SAFETY NOTE – URGENT MODIFICATION

A modification needs to be done to every 2010 brake toggle produced with the Small plastic buckle under neoprene fabric.

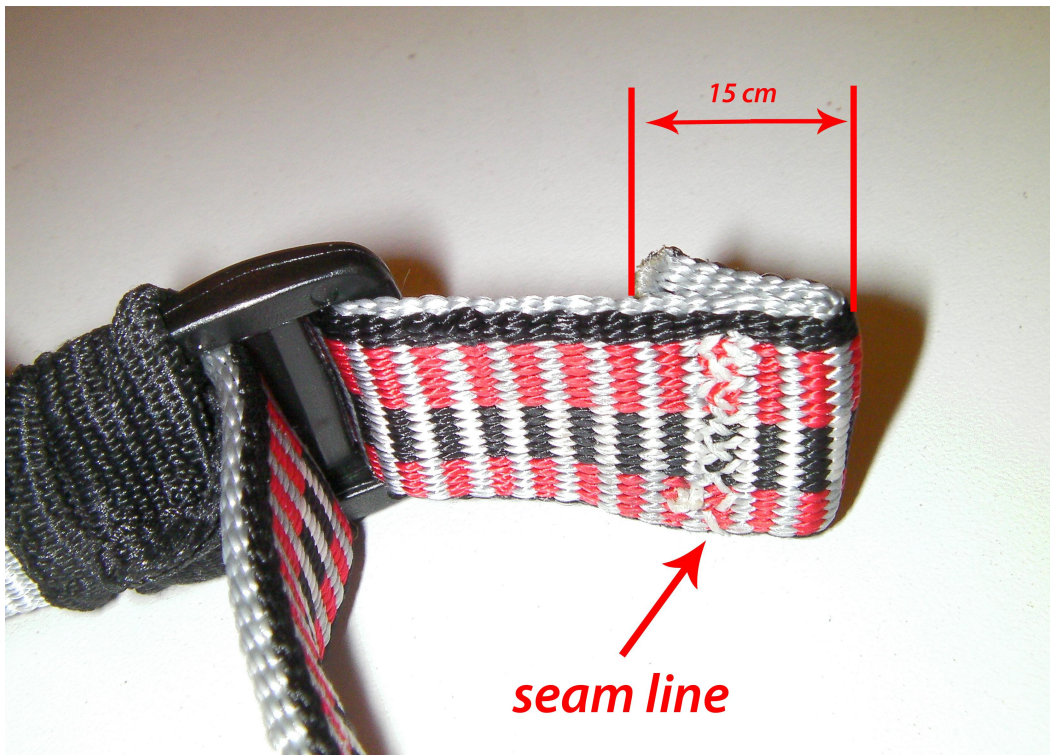
In certain circumstances, the toggle webbing can extricate itself from the plastic buckle or the plastic buckle can be easily damaged.

This can be dangerous to the user. We would like to ask you to make modification as instructions below.

1. Fold the end of the strap and sew it together

2. Adjust the brakes size as needed and replace the neoprene over the plastic buckle
